Addendum #03

Date: July 14, 2021

Project: Huntington Middle School Modernization and Addition

BEDDING AND
TRENCHING
STANDARD
DETAILS

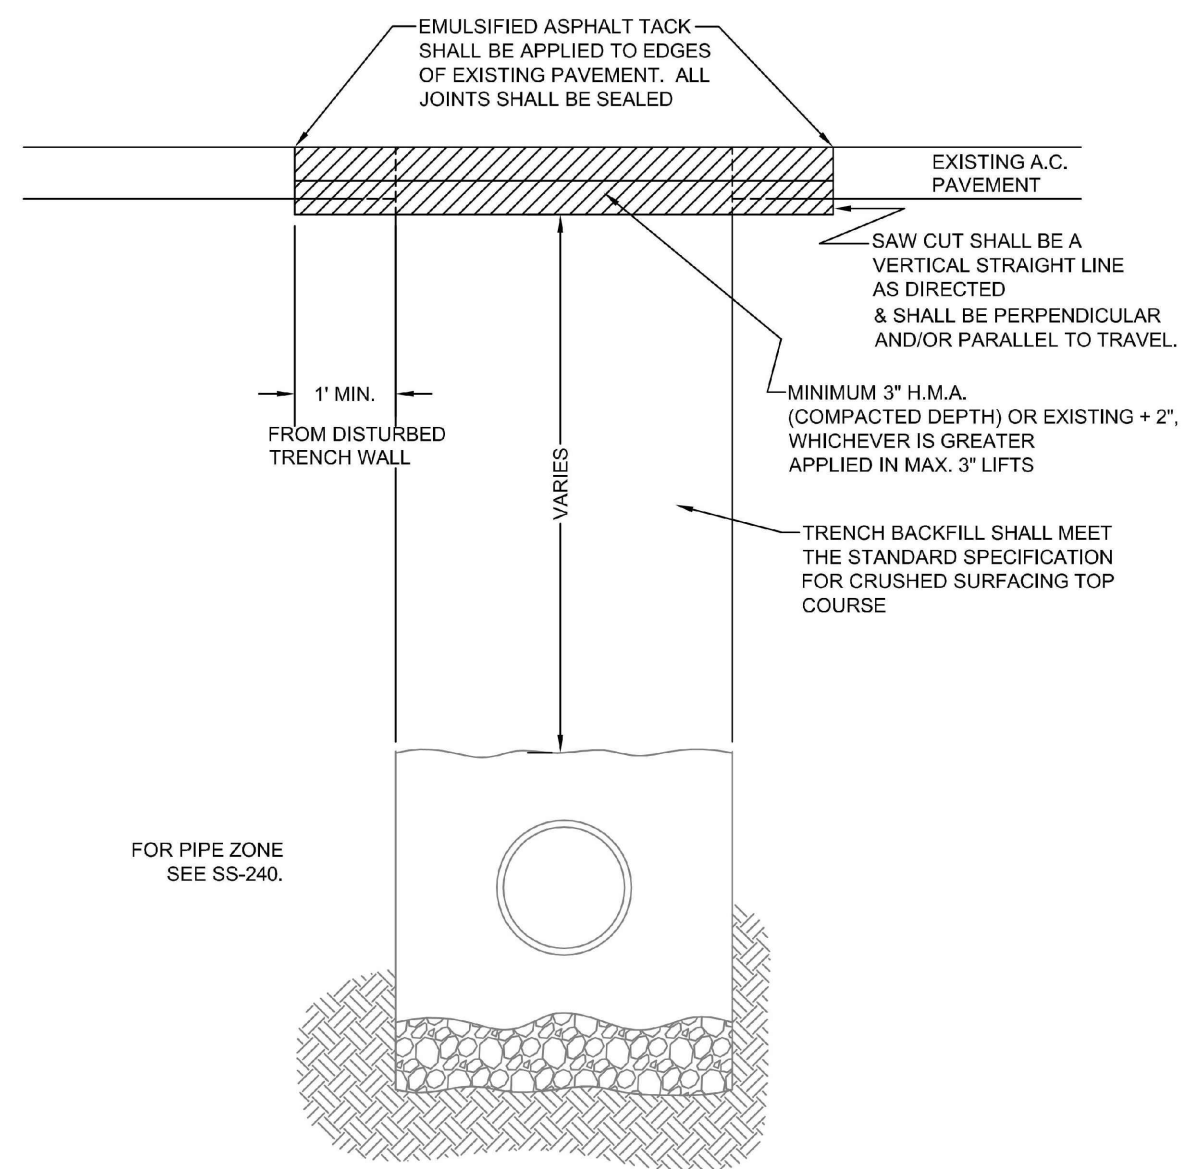
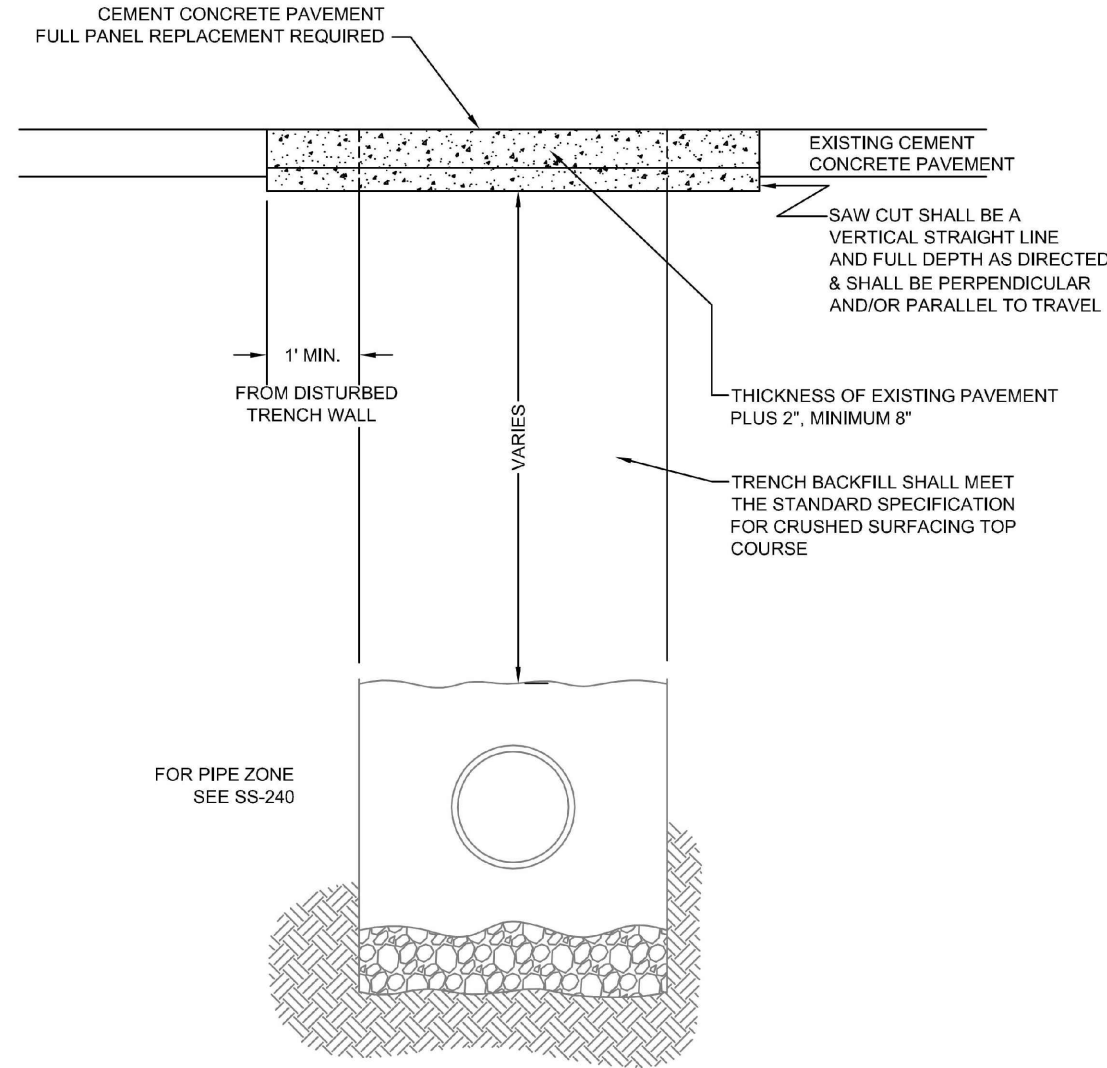
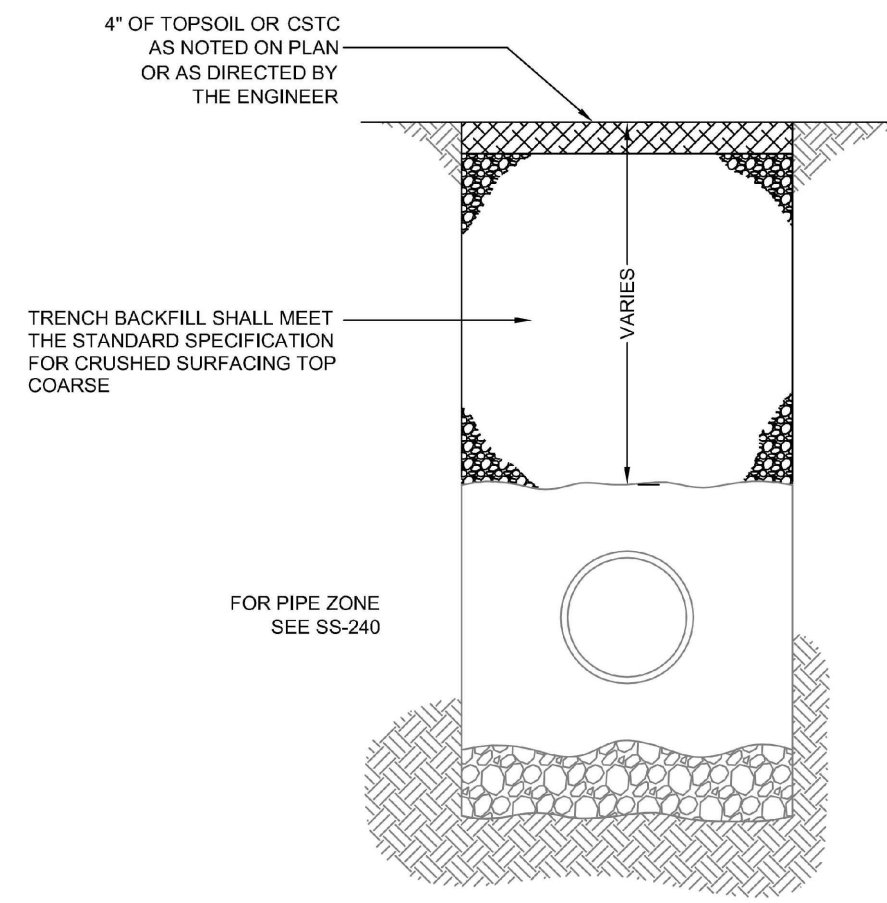
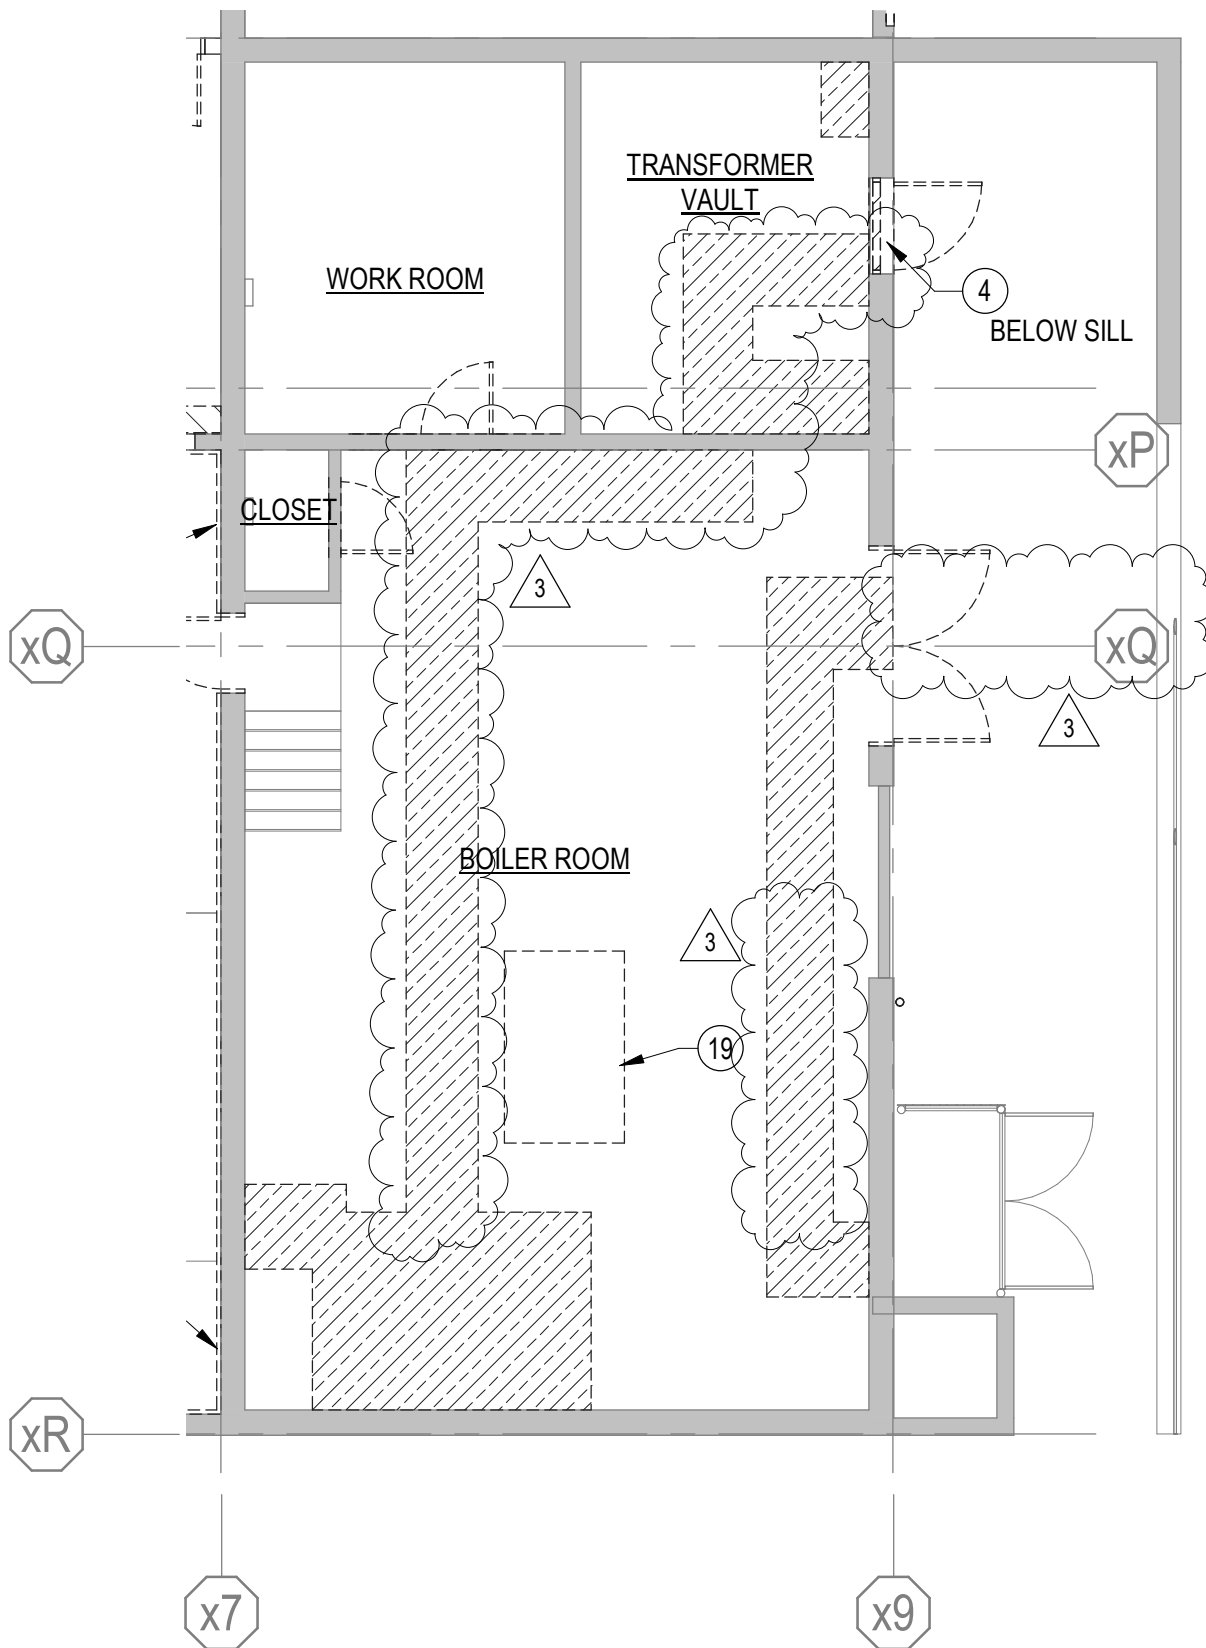
Item #C04 C605 – Bedding and Trenching Standard Details
Add. #03 **Add** WSDOT Catch Basin and Grate Details as shown on the attached C605.

DWG. #: **ADD-001**
 JOB #: 21938
 DRAWN BY: EP
 DATE: 07/14/21
 REF. DOC.: ADDENDUM 03

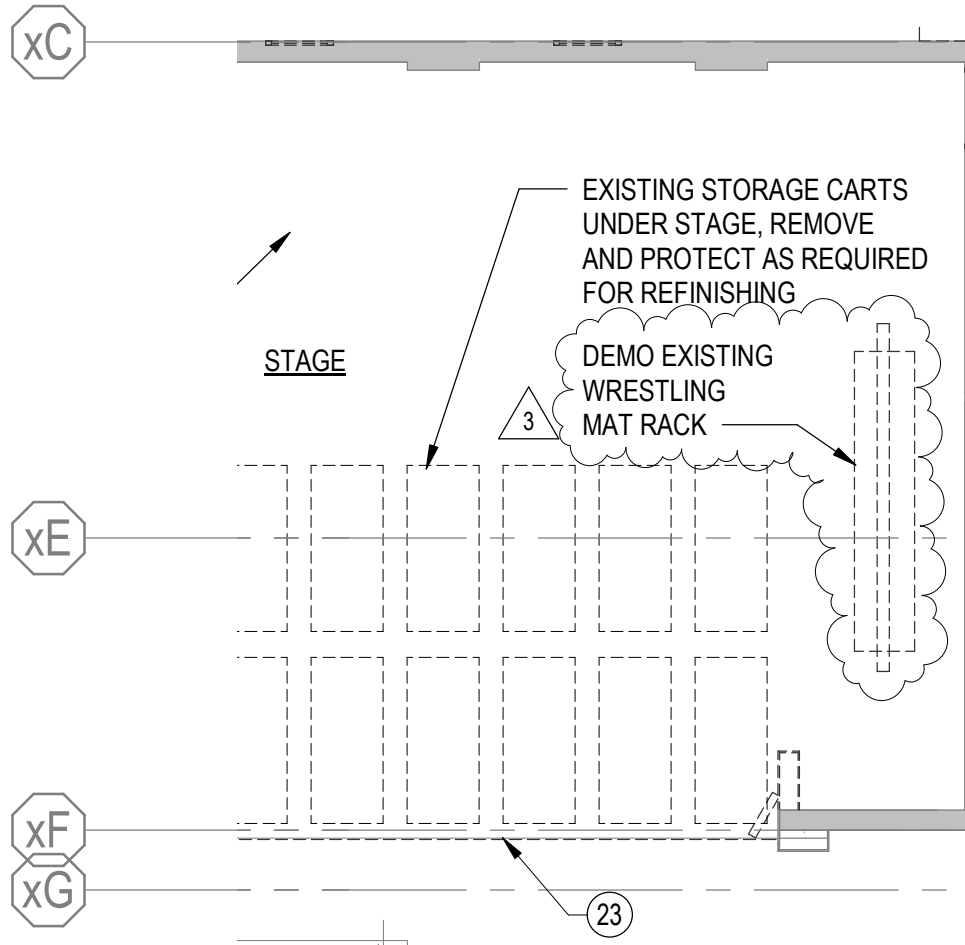
Item #AD1 AD100A - LEVEL 0 AREA A - DEMO FLOOR PLAN

Add. #03 **Revise** per sketch **ADD-001**.

FINISH & COLOR
SCHEDULE

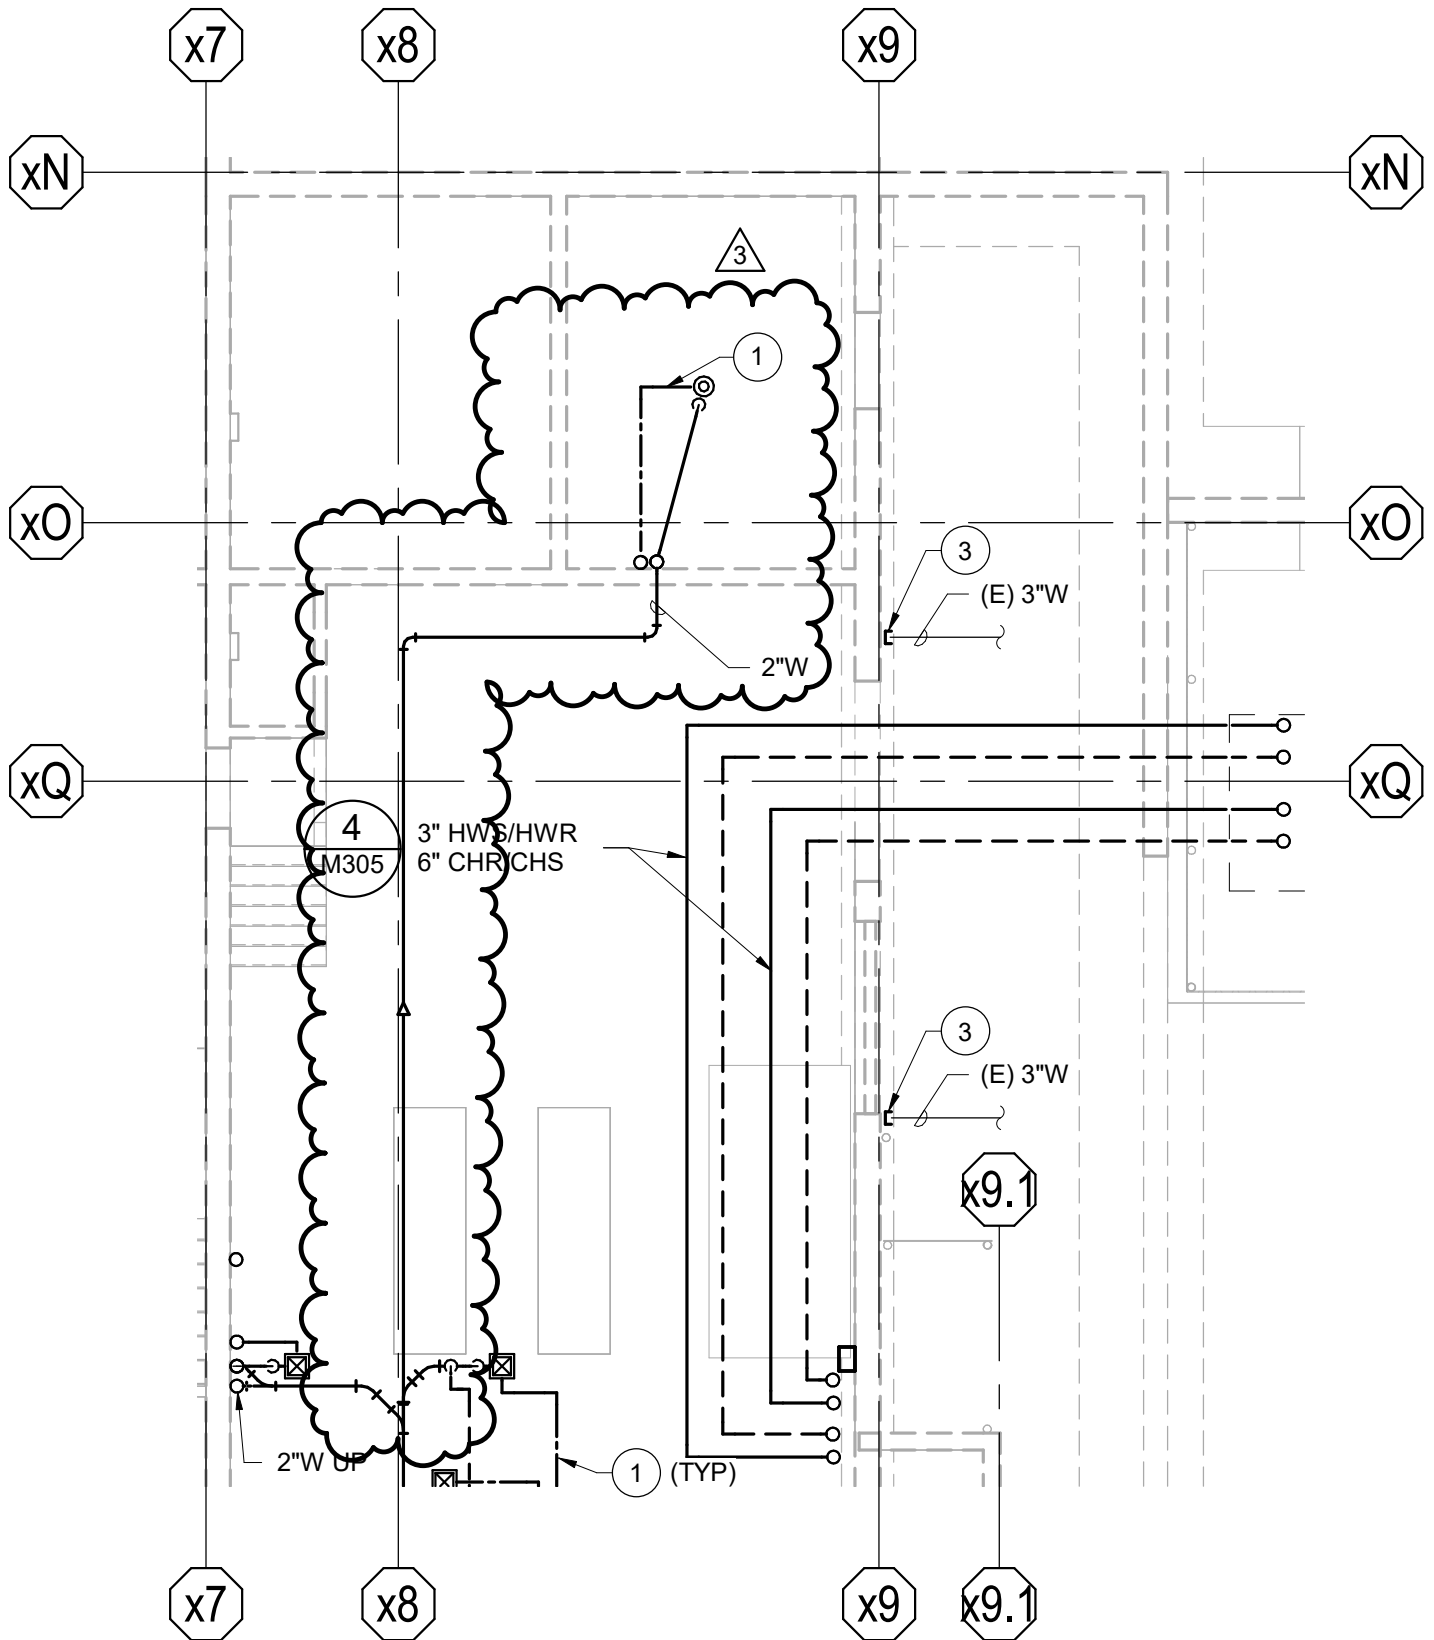
Item #A05 A400 – FINISH & COLOR SCHEDULE

Add. #03 **Revise** per attached sheet **A400**.
